Consultation response

St Mary's Roundabout/Forest Road junction proposals

February 2018

B&Q roundabout

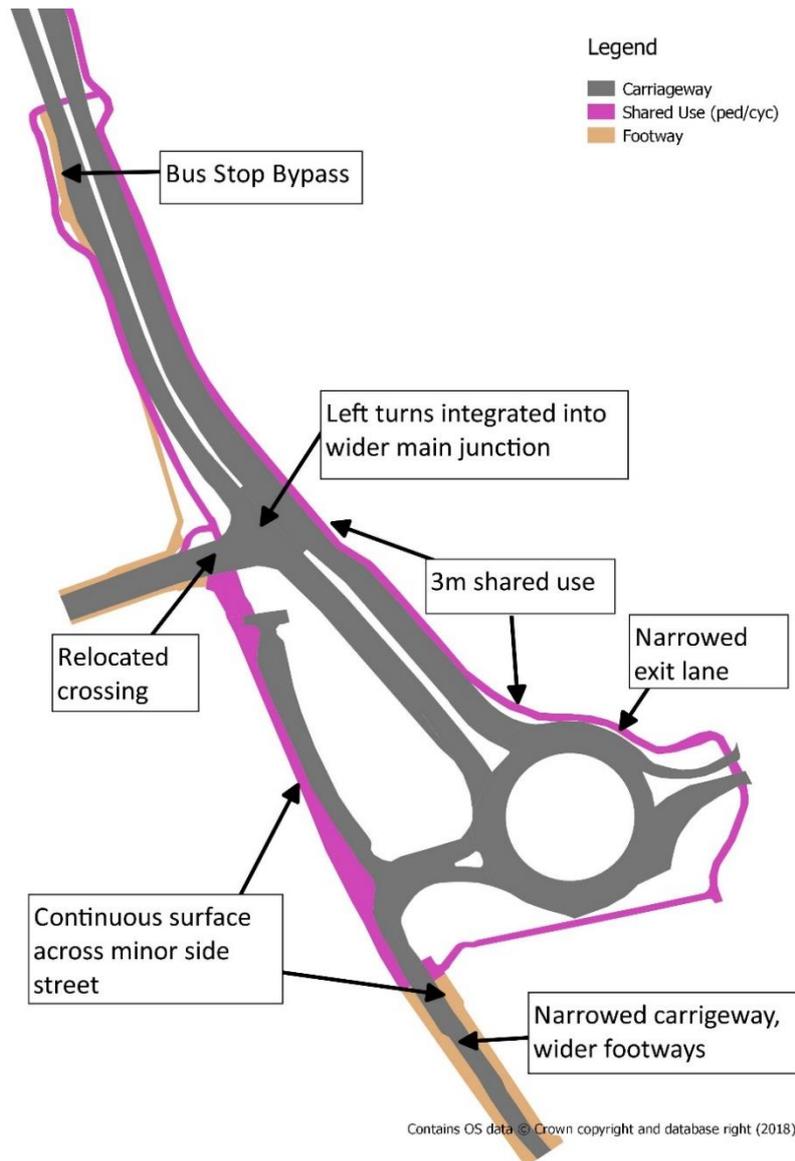
Traffic leaving the St Mary's roundabout towards the smaller B&Q roundabout does so at speed, with no little sense of transition from a high-speed to low-speed environment. The pedestrian crossing at this point involves a wide road crossing and fast-moving vehicles whose attention is focused on other vehicles rather than pedestrians. Minor remodelling of this short section of road would enable traffic to be slowed as it exits St Mary's roundabout and focus attention more onto the crossing point. It is clear that HGVs need to be accommodated to service the Industrial Estate, but some road narrowing could take place without detriment to HGV movements, and further narrowing of the main carriageway could be undertaken with an overrun area added for HGVs. The crossing point could be narrowed, and the central refuge widened. These improvements would increase safety and comfort for pedestrians, allow for the creation of a cycle crossing and have minimal or no reduction of vehicle capacity.

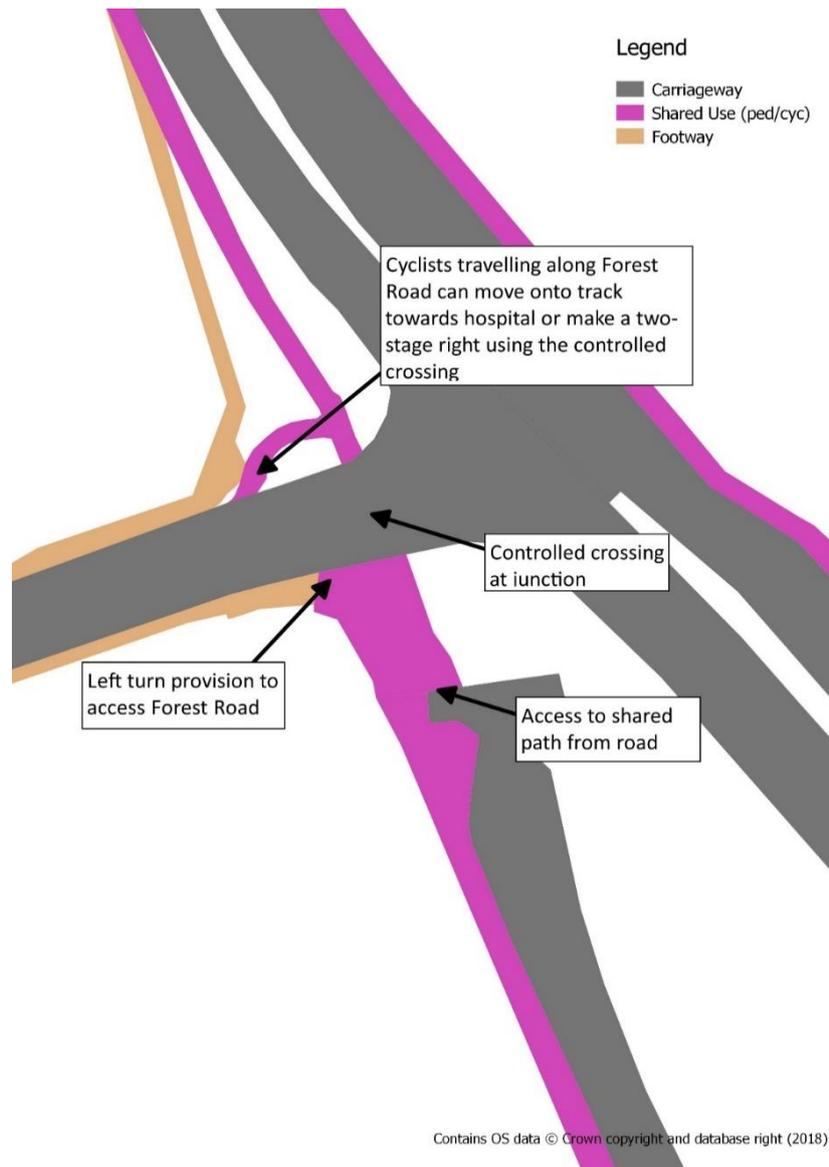
Outline of an alternative approach, with improved access to/from shared route, fewer conflict points and more direct routes for people cycling and walking. Provision is also made on the eastern side to accommodate a much wider range of trips and ultimately provide a continuous all-ability route to Newport. **N.B. Diagram is illustrative only.** We would be happy to discuss the concept further.

Closer view of Forest Road/Medina Way junction. Reintegrating left turns into the main junction (further widened to accommodate HGV turning) allows removal of the Toucan crossing with substandard waiting areas and poor cycle access and creation of a more direct cycle route, integrated with the main traffic lights at the junction. This arrangement also creates proper access to/from Forest Road. **N.B. Diagram is illustrative only.** We would be happy to discuss the concept further.
